2714 DUNSMUIR, CUMBERLAND

HERITAGE ALTERATION PERMIT AMENDMENT COMPARISON TO PREVIOUS DESIGN

2022.09.06

OVERLAY OF NEW BUILDING

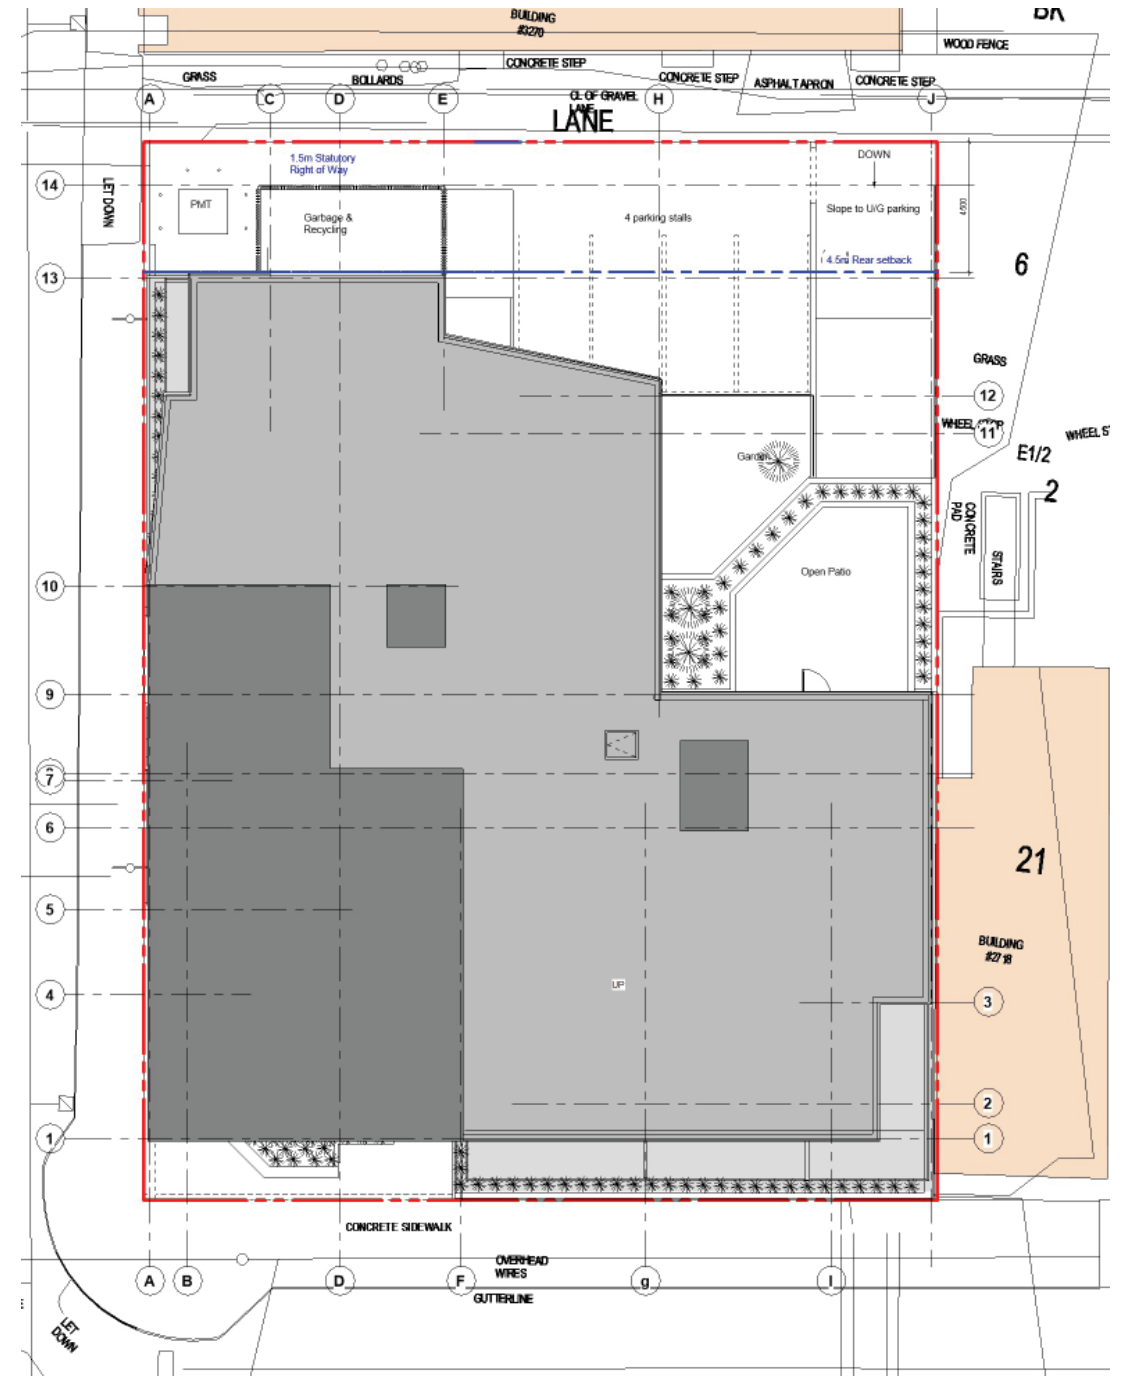
1/ WITH RESPECT TO THE ORIGINAL DP DESIGN THE MASSING OF THE BUILDING HAS BEEN AMENDED DUE TO AN ELECTRICAL SETBACK (3M FROM POWER LINES)

2/ THE CORNER MASSING HAS BEEN RECESSED BY 2.06M

MAIN FLOOR PLAN

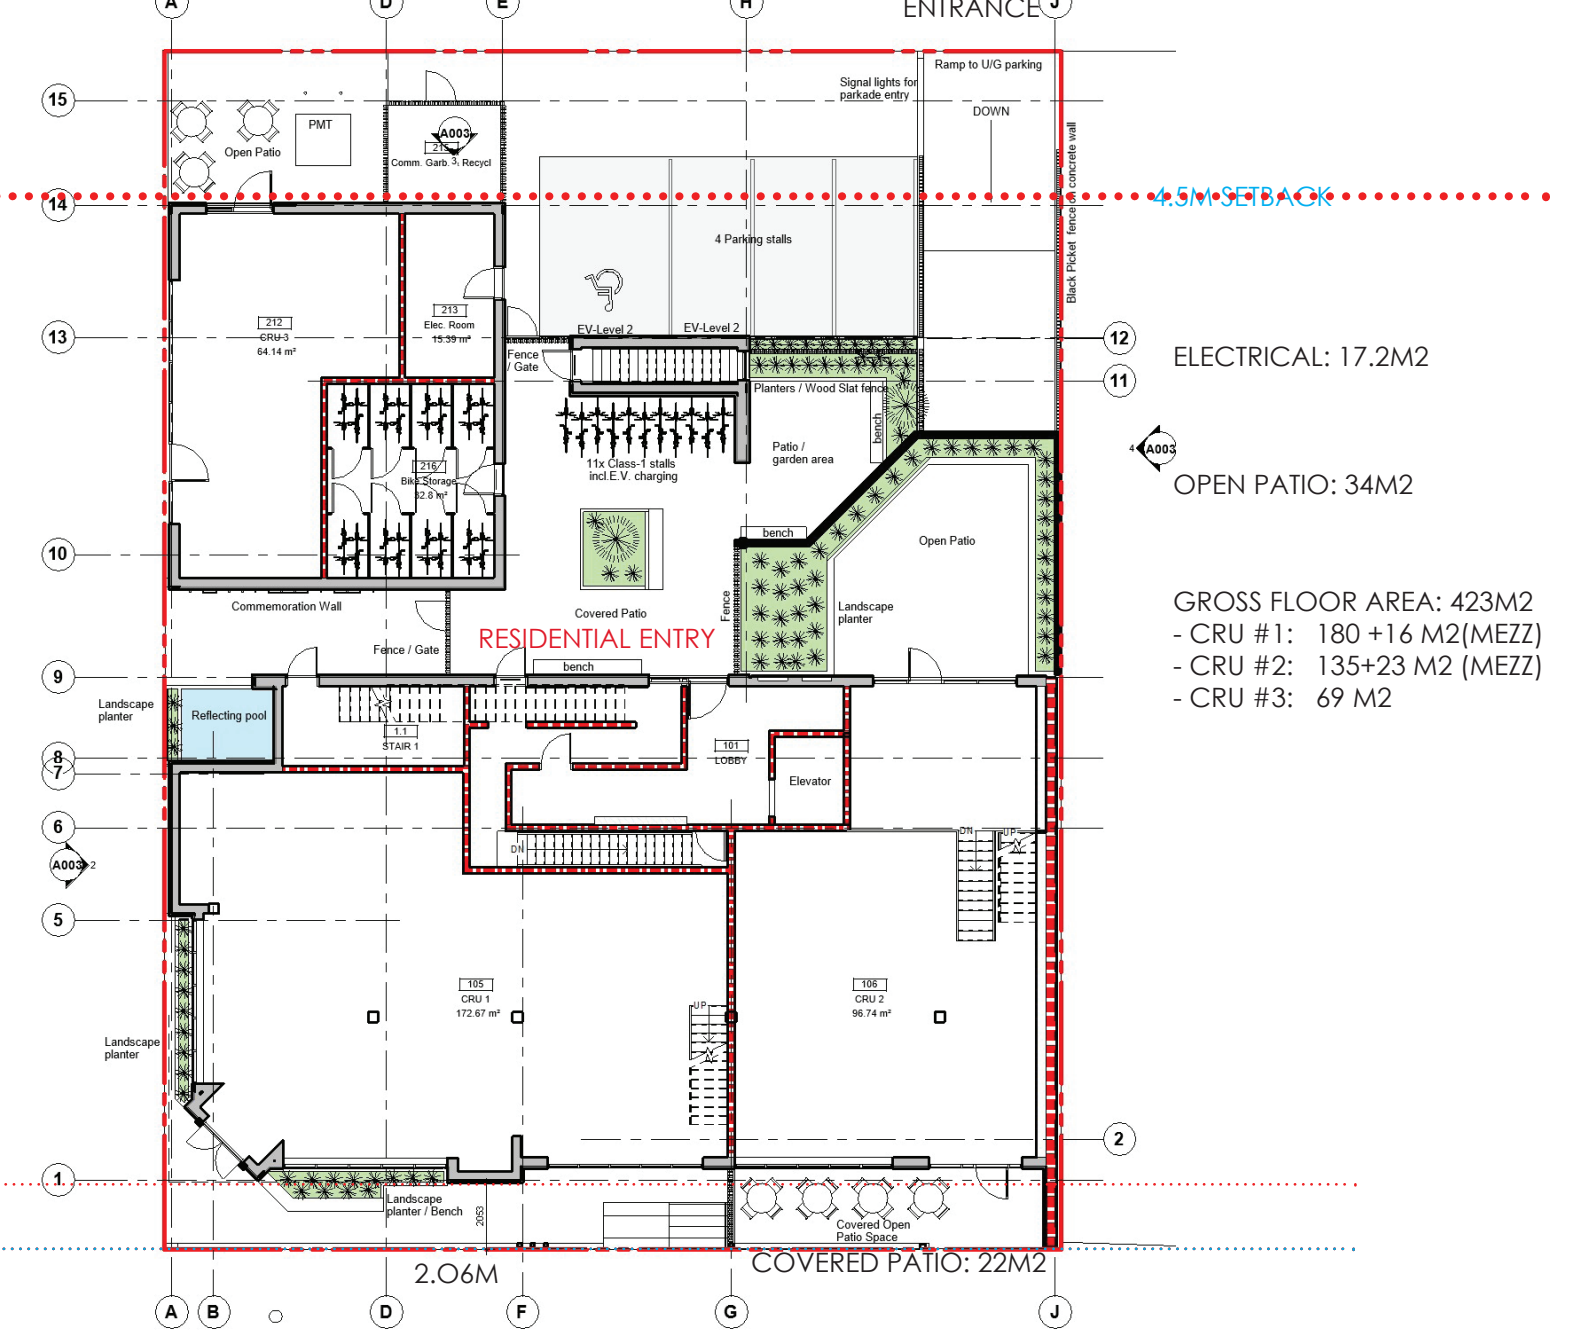
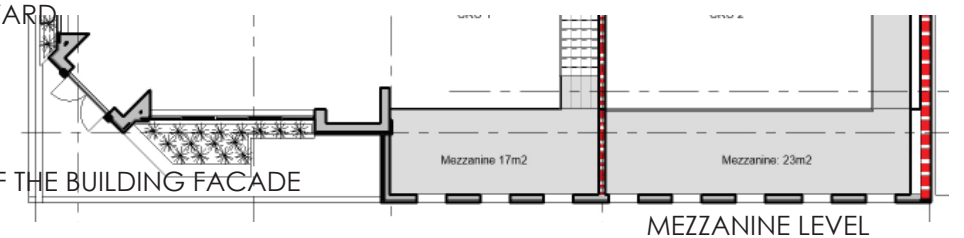
SETBACK DUE TO HYDRO LINE
 SINGLE RESIDENTIAL MAIN ENTRANCE IN COURTYARD

FRONT SETBACK:
 - REQUIRED: MIN. 0M
 MAX 1.0M FOR A MIN OF 75 % OF THE BUILDING FACADE
 - PROPOSED: 0-2.06M **

2ND FLOOR PLAN

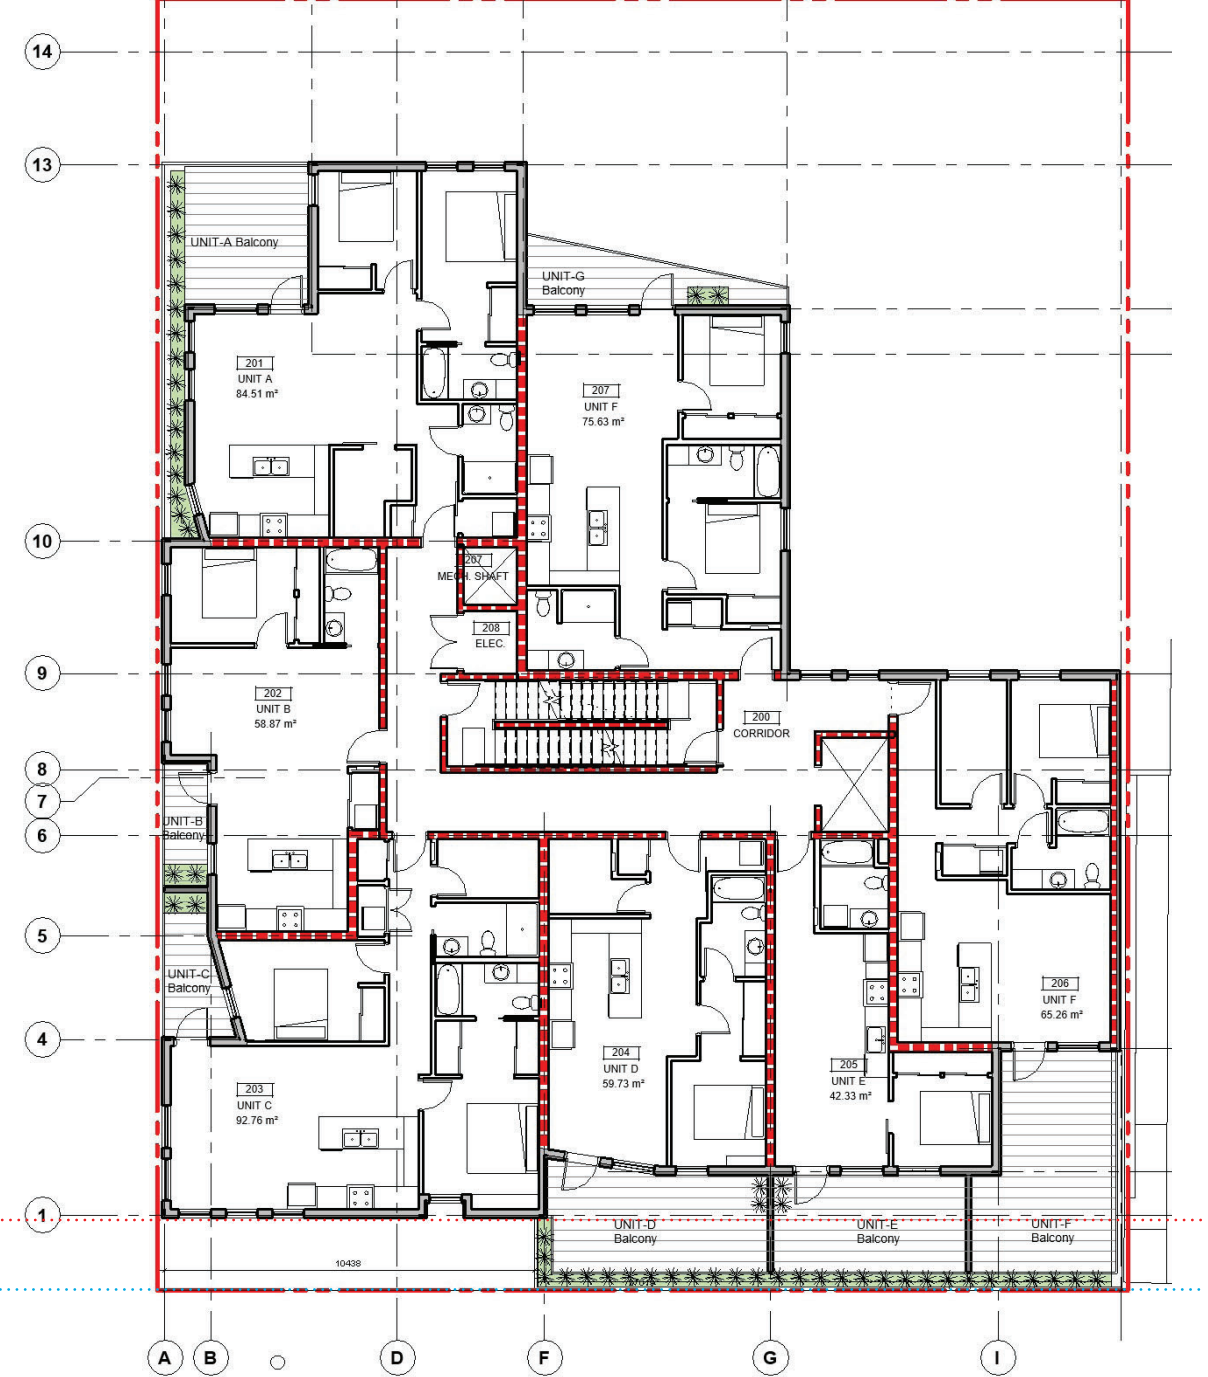
FOOTPRINT WAS BEEN INCREASED
2 EXTRA UNITS PER FLOOR

3TH FLOOR PLAN

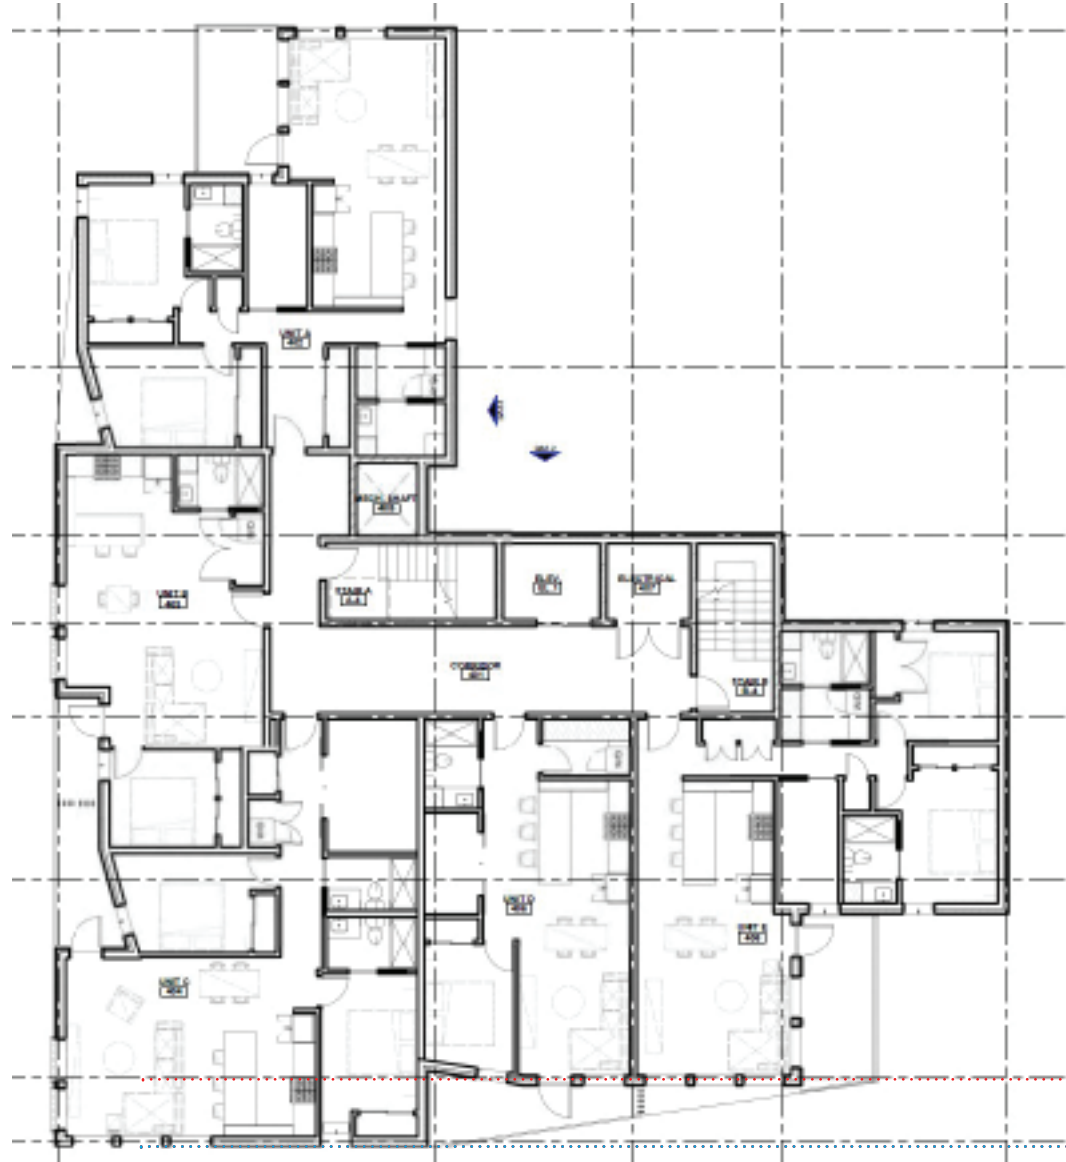
FOOT PRINT WAS BEEN INCREASED
2 EXTRA UNITS PER FLOOR

4TH FLOOR PLAN

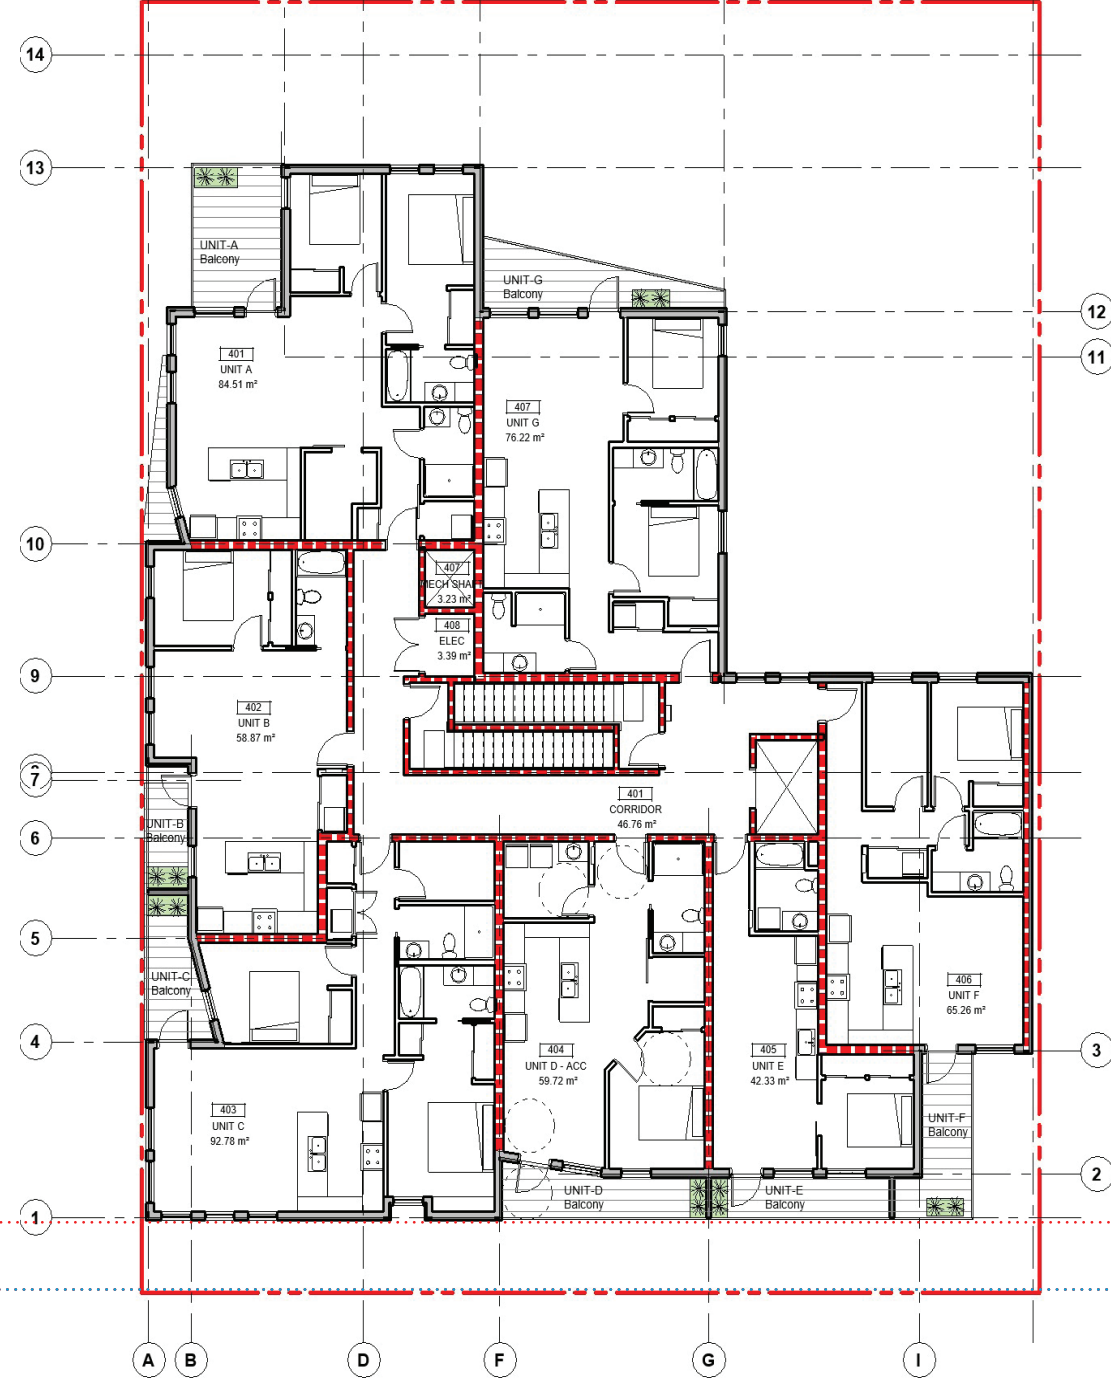
FOOT PRINT WAS BEEN INCREASED
2 EXTRA UNITS PER FLOOR
